**Report to
Development Permit Panel**

To: Development Permit Panel
From: Brian J. Jackson, MCIP
Director of Development
Date: April 28, 2010
File: DP 06-350001
Re: **Application by Matthew Cheng Architect Inc. for a Development Permit at
9631, 9651 and 9671 No. 4 Road**

Excerpt from the Minutes from
The Design Panel Meeting

APR 20 2010
PLAN #2

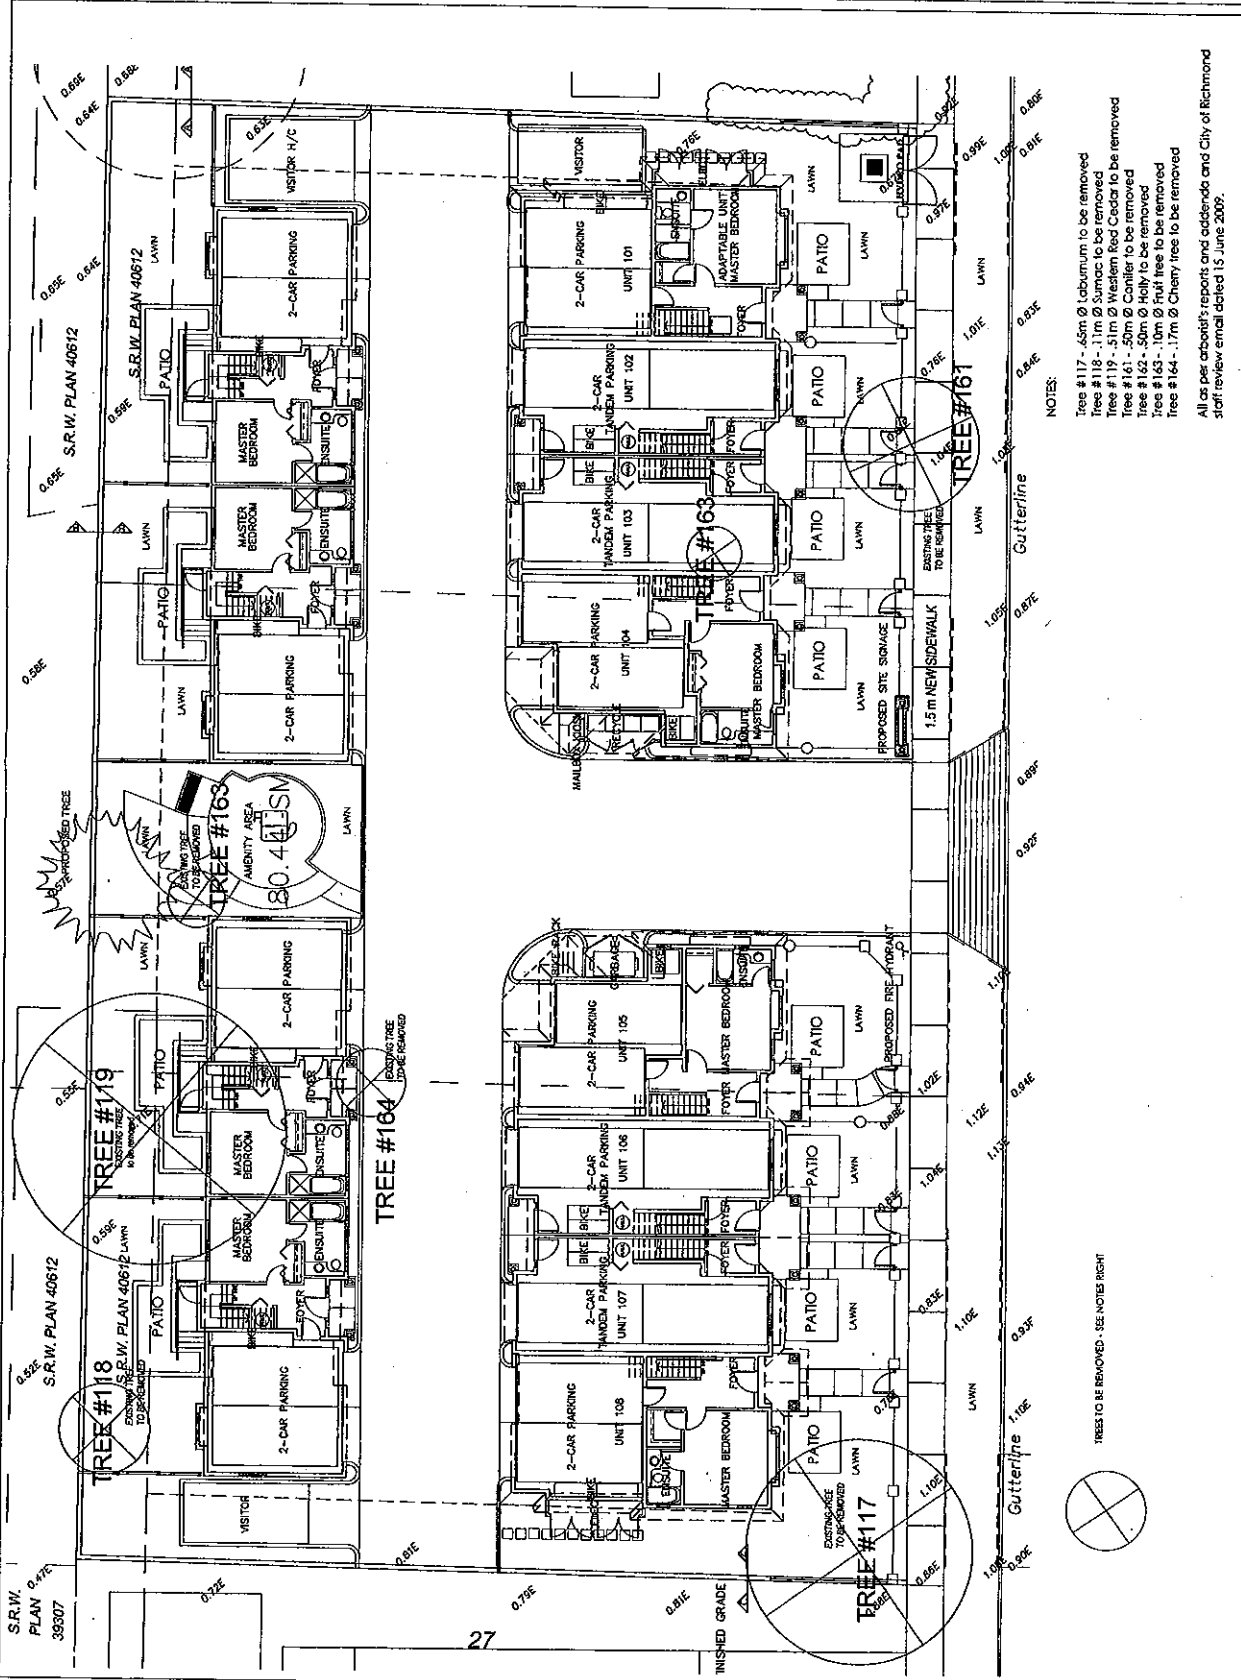
- Seven (7) bylaw-size trees were noted on-site and were identified for removal at the rezoning stage. The City's Tree Preservation Coordinator reviewed the Arborist's Report and concurred with the Arborist's recommendations based on the poor health of trees (4 trees) and conflicts with the proposed development (3 trees).

- The site plan and tree preservation scheme were once again reviewed at the Development Permit stage. Due to the locations of the central drive aisle and buildings, as well as the proposed grade changes, all of the seven (7) trees on site are to be removed.

- Tree #117 - 45m @ Lobum to be removed
- Tree #118 - 11m @ Sumac to be removed
- Tree #119 - 51m @ Western Red Cedar to be removed
- Tree #161 - 50m @ Holly to be removed
- Tree #162 - 50m @ Holly to be removed
- Tree #163 - 10m @ Holly to be removed
- Tree #164 - 17m @ Cherry to be removed

APR 28 2010
PLAN #4C

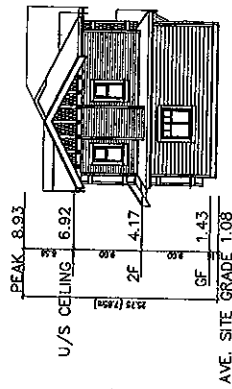
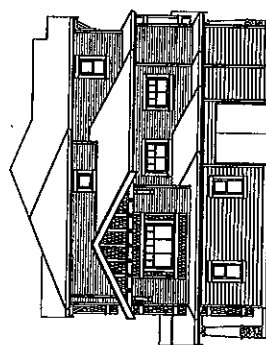
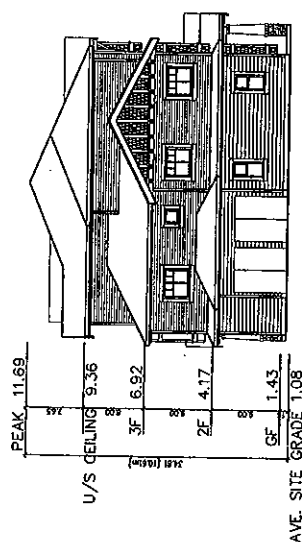
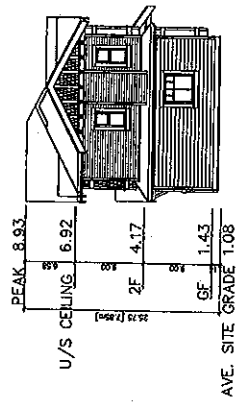
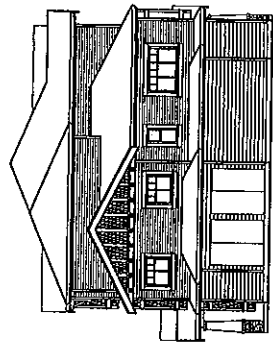
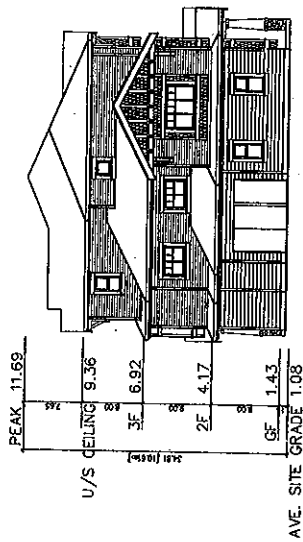
1. consider modifying the roof line/eave line of the east blocks facing No. 4 Road to express the individual units more clearly and reduce the scale and height of the roof line as it relates to the back units;

The scale of the front buildings is reduced by changing the building end gables to hip roof. The building height for both buildings is also further reduced to 10.46m. Each unit is expressed vertically by protruding building mass and box windows with gable end treatment.
